Access Compliance Report Public Rights-of-Way (Curb Ramps)

Main Street: N/A Cross Street: CONTIGO_PL Location: W

ADA ID: RPRK211203133851 Ramp Type: Type 6 - Directional 1 Initial Pass/Fail: Pass Overall Compliance: No Severity Score: 10

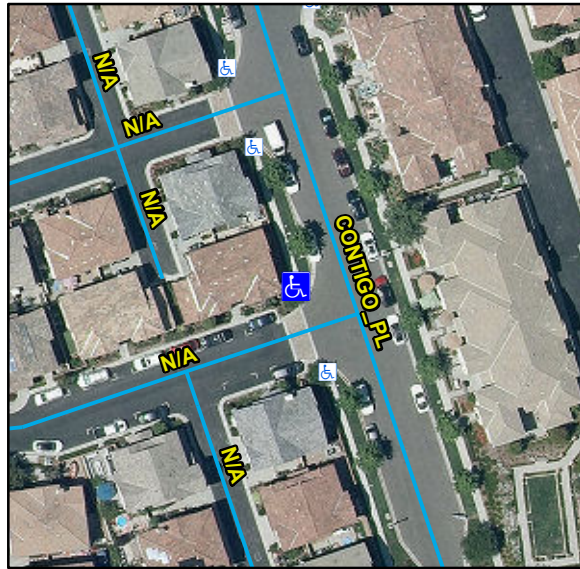
Compliance	Description	Data	Compliance	Description	Data
N/A	Ramp Length (in)	104	Yes	Flare Type LT	Curbed2
Yes	Ramp Width (in)	72			
Yes	Ramp Run Slope (%)	5.6	N/A	Flare Slope LT (%)	N/A
Yes	Ramp Cross Slope (%)	1.9	N/A	Flare Traversable LT	N/A
Yes	Grade Break	Yes	N/A	Flare Type RT	
No	Grade Break Slope (%)	8.5			Sloped
Yes	Grade Break Cross Slope (%)	2.7	N/A	Flare Slope RT (%)	18.2
	Addl Para Ramp Left?	No	N/A	Flare Traversable RT	No
	Addl Para Ramp Right?	No	Yes	DWS Provided	Yes
N/A	Landing Present	Yes	Yes	DWS Contrast	Yes
Yes	Landing Length (in)	54	Yes	DWS Length (in)	72
Yes	Landing Width (in)	48	Yes	DWS Full Width	Yes
No	Landing Run Slope (%)	6.5		DWS Offset Type	Single
Yes	Landing Cross Slope (%)	1.4	Yes	DWS Left Offset (in)	0
N/A	Landing Movement Obstructed?	No	N/A	DWS Right Offset (in)	0
	Landing Movement Type	N/A			
N/A	Landing Shared	No			
N/A	Marked Crosswalk 1	No	N/A	Clear Space	N/A
	Crossing 1 Direction	S	N/A	Clear Space To Crosswalk (in)	N/A

Marked Crosswalk 1 Width (in)	N/A			
N/A	Ramp Inside Crosswalk 1	N/A			
	Crossing 1 Slope (%)	4.1			
	Crossing 1 Cross Slope (%)	6			
Yes	Gutter Ponding	No	Yes	Curb Slope	7.8
Yes	Gutter Lip Height (in)	0		Road Run Slope (%)	N/A
No	Gutter Run Slope (%)	5.1		Road Cross Slope (%)	N/A
Yes	Gutter Cross Slope (%)	1.7		Parallel Ramp Side	N/A
Yes	Overall Surface Condition	Acceptable	Yes	Perp Joint Present	Yes
	Cross Gutter Present?	No		Spandrel Present?	No
	Replace Cross Gutter?	N/A		Replace Spandrel?	N/A

Remove & Replace Entire Ramp. Remove & Replace Gutter.
